City of Red Bank
Municipal Planning Commission

REGULAR MEETING AGENDA

July 20, 2023

To: Members of the Red Bank Planning Commission
Cc: Greg Tate, Public Works Director
From: Ashley Gates, Senior Planner, Southeast Tennessee Development District
Date: July 6, 2023
Subject: Final Plat for Lima at Lullwater

Final Plat
Lots 1-26

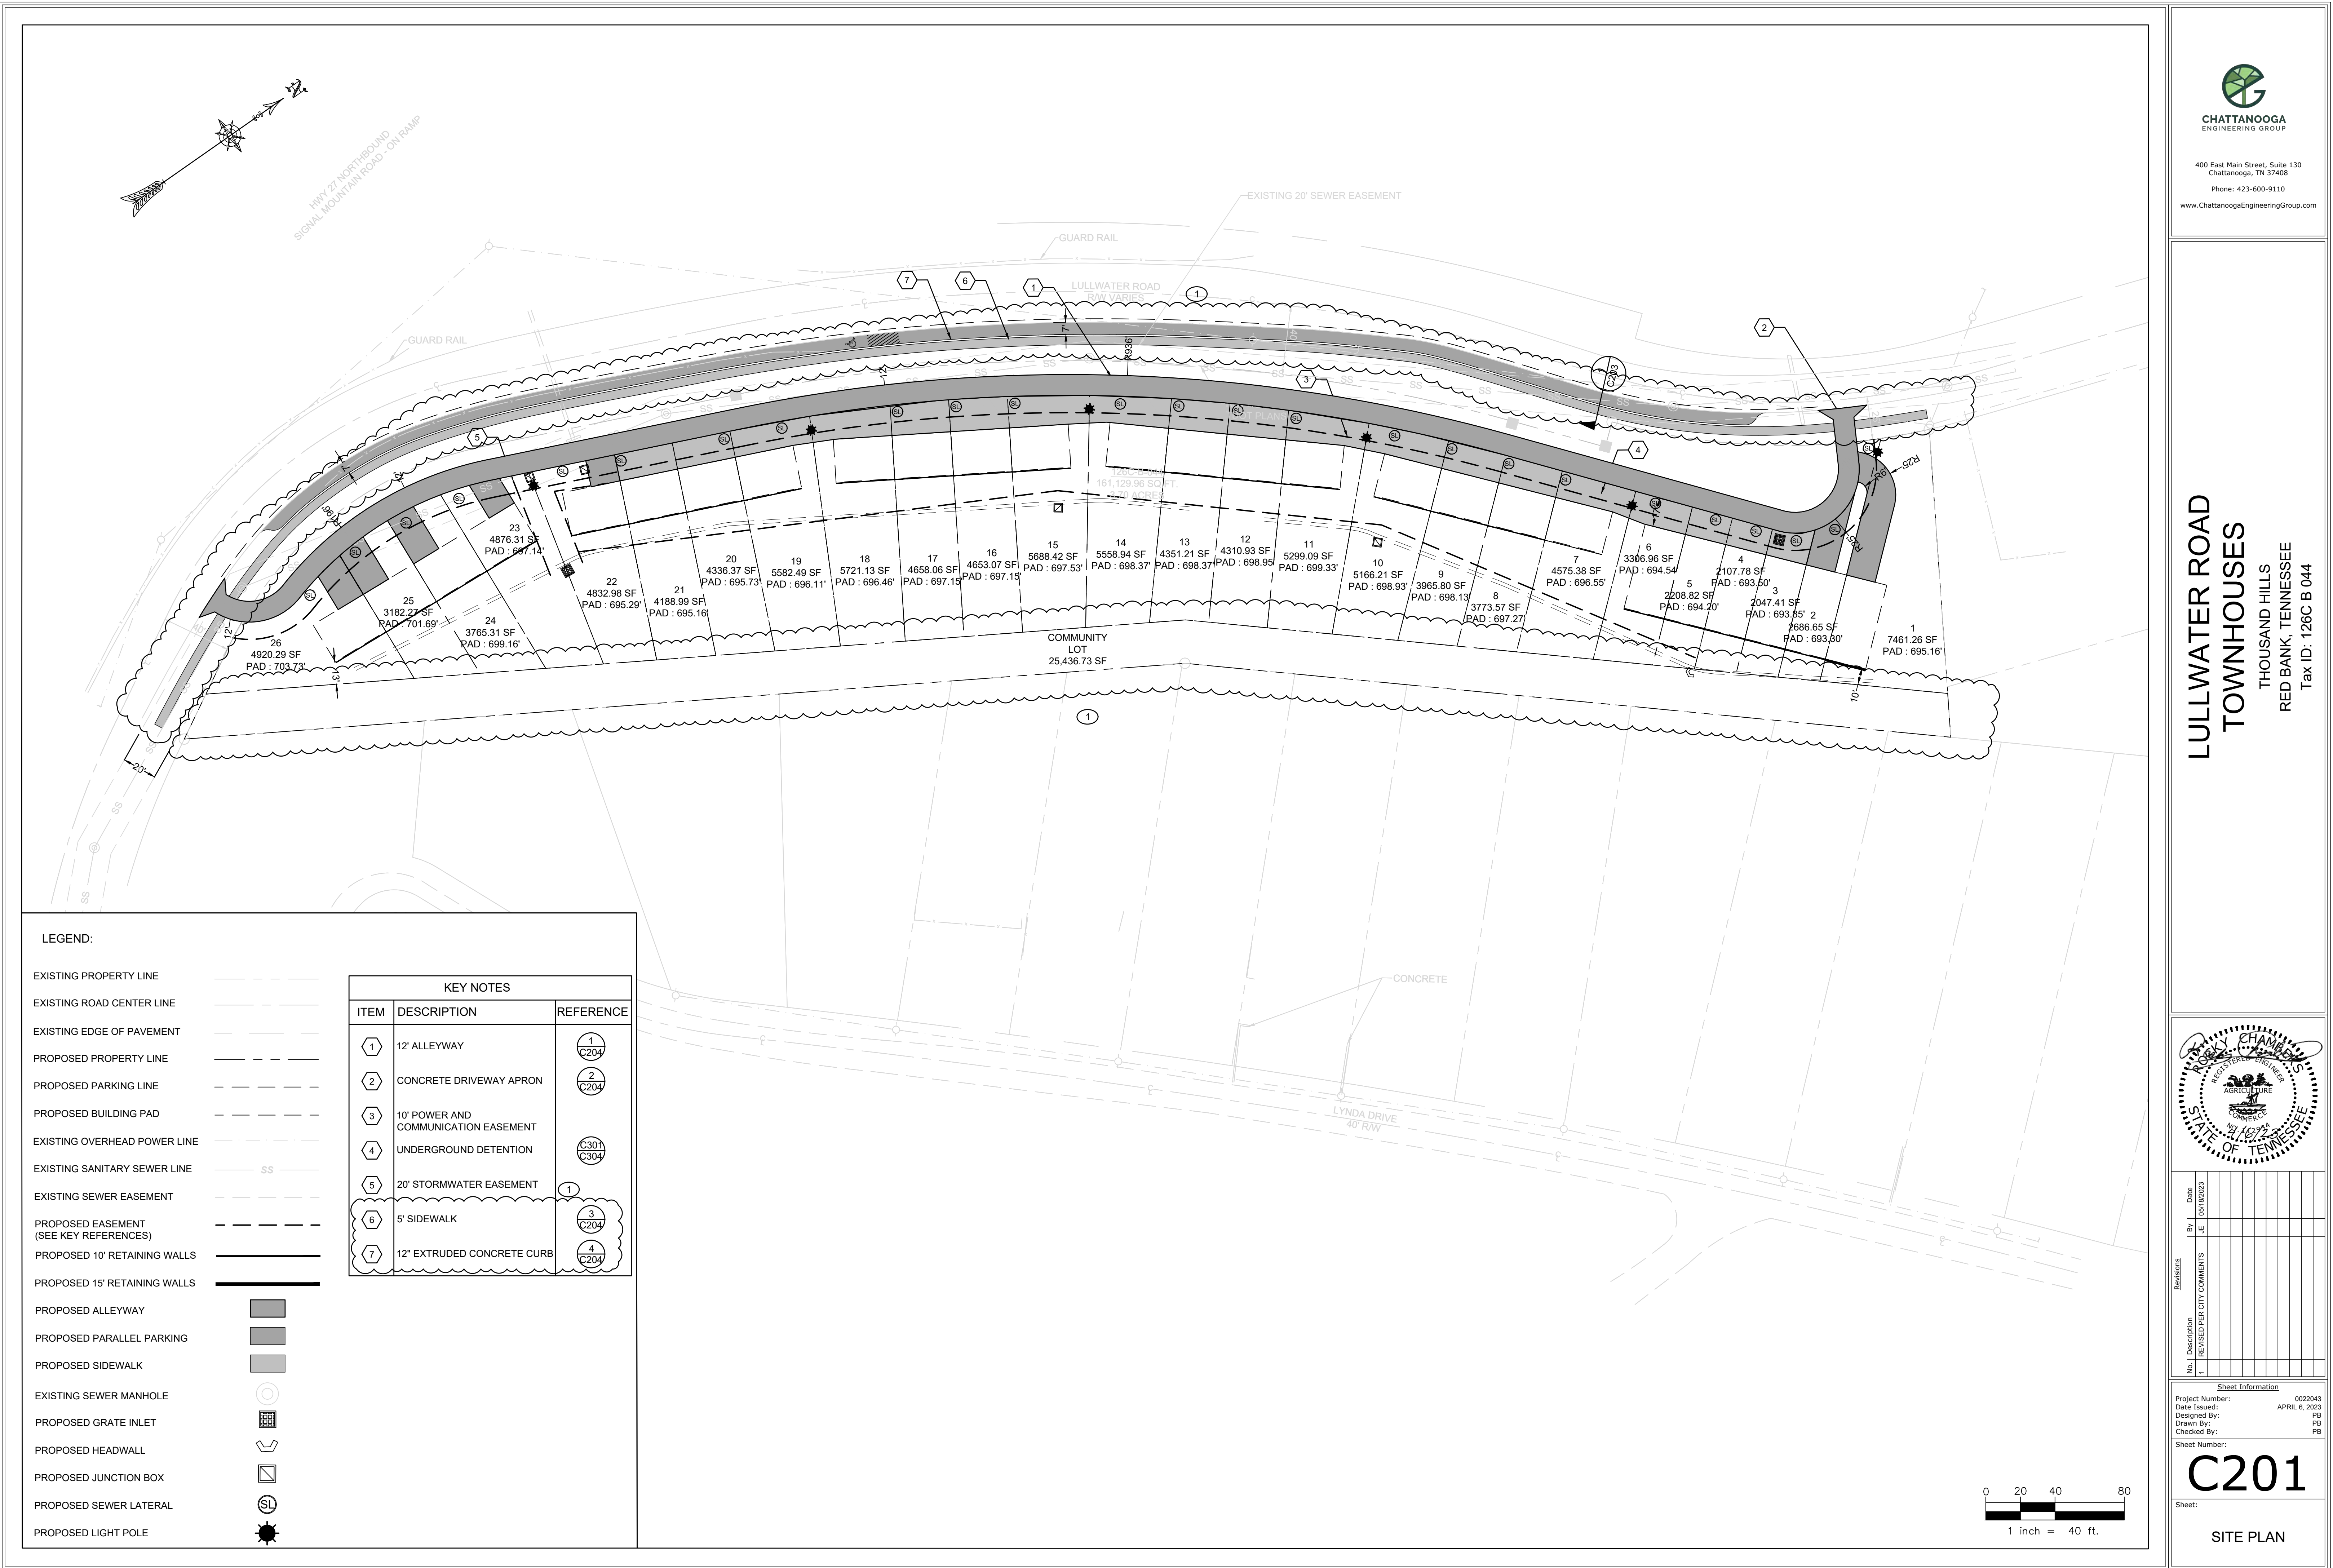
This plat must be submitted as a PRELIMINARY Plat. The following is still needed for a complete preliminary plat submittal:

- Size and location of proposed water lines
- Location of proposed fire hydrants
- Certificate of Preliminary Plat Approval
- Vertical road profile of proposed access road
- Vertical sanitary sewer profiles

The following additional information to assess compliance with the Zoning Ordinance is needed:

- Measurements of building separation
- Side setback measurements for exterior side lot lines. Minimum is 25 feet.
- Show all setback lines on the plat

This plat does not meet the following requirements of the Zoning Ordinance:

- Several proposed structures do not appear to meet the rear setback requirement of 25 feet
- The front setback requirement is 40 feet along exterior roads, unless Type C landscaping is provided, in which case the minimum is 25 feet. The front lot lines on the site plan do not appear to match those on the plat. Additional clarification is needed to assess the front setbacks.

- Regarding proposed access via alley:
 - o Proposed access road does not meet the standards of a frontage road as defined in the Zoning Ordinance, which requires frontage roads to meet Subdivision Regulation standards and to be dedicated as public roads. The minimum paved width of local streets is 26 feet.

- o Alleys are defined as secondary vehicular access and are generally provided at the rear of the homes. Placing an alley between the road and the home makes the alley the primary vehicular access, which is a frontage road not an alley.

- o Access via private access easement is limited to only 4 lots per the Subdivision Regulations, so those standards do not apply.
 - o The Fire Department has indicated that as designed, this road would serve as fire access. The Fire Department requires a minimum width of 22 feet, though the Subdivision Regulations require 26 feet.

- o Alley should either be designed to meet the “Frontage Road” requirements of the Zoning Ordinance or moved to the rear of the townhomes. If moved to the rear, the Fire Department will need to review the new design.

- o Vertical profiles of alleyway needed to ensure sight distance at intersection with Lullwater Road.
 - o Minimum horizontal curve radius is 100 feet, this measurement is needed

- Parallel parking spaces are too narrow at 7 feet. Recommend that they be 9 feet wide.
- Guard rails will need to be replaced. Please show proposed location of guard rails.

- The Red Bank Fire Department requires that all structures be within 500' of a fire hydrant. This is due to the complexity and density of the development. There is 6" main ending at the address 307 Lullwater, but the closest fire hydrant is in front of 433 Lullwater, which is more than 500' from the furthest lot on the plat. Show all proposed fire hydrants.

Due to the needed corrections and significant change from the conditionally approved rezoning, staff cannot recommend approval at this time.

Staff recommends the following options:

- A. Resubmit a plat that meets the intent of the rezoning from 2017, with the same density and general layout, and that addresses the concerns listed above.
- B. Submit an application to amend the conditions of the 2017 rezoning, then resubmit the plat and site plat addressing the corrections indicated above.

SITE PLAN

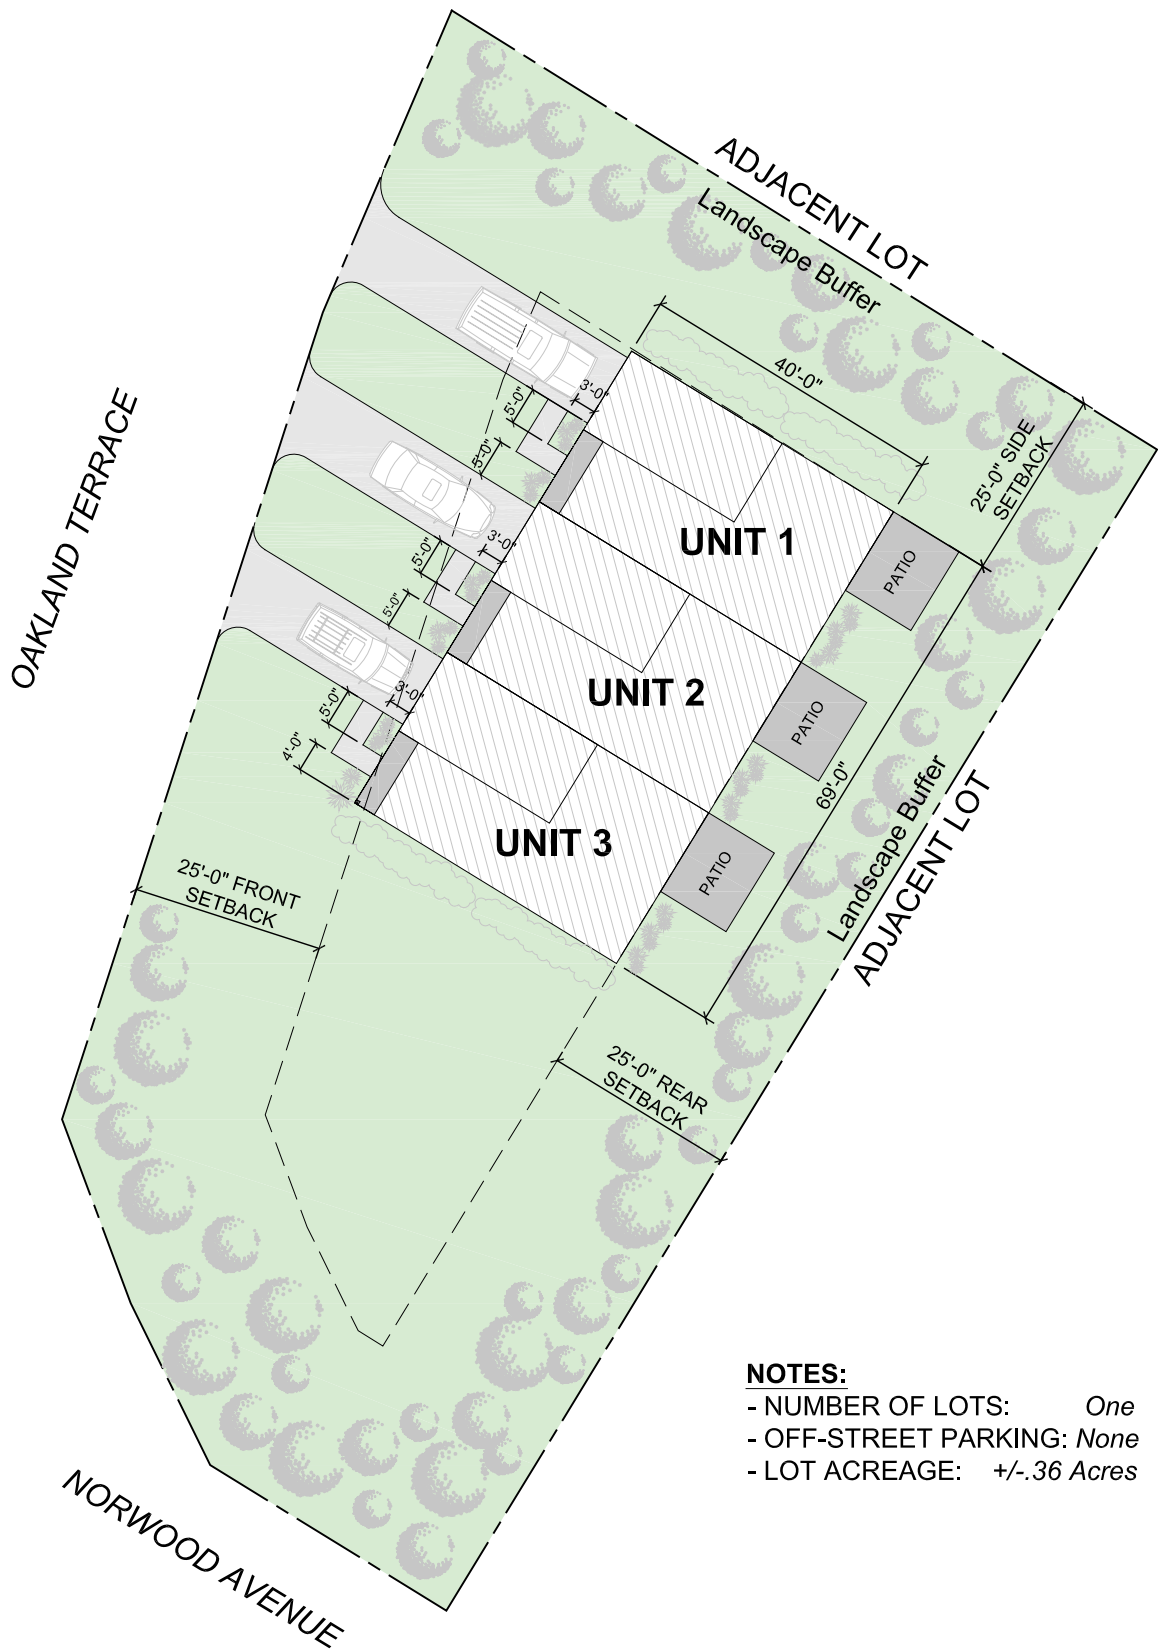
Attached site plan submitted for July meeting.

For 25-foot front setback, as shown, Type C landscaping is required. Staff requests review by Codes Enforcement as to the recommended placement of this landscaping.
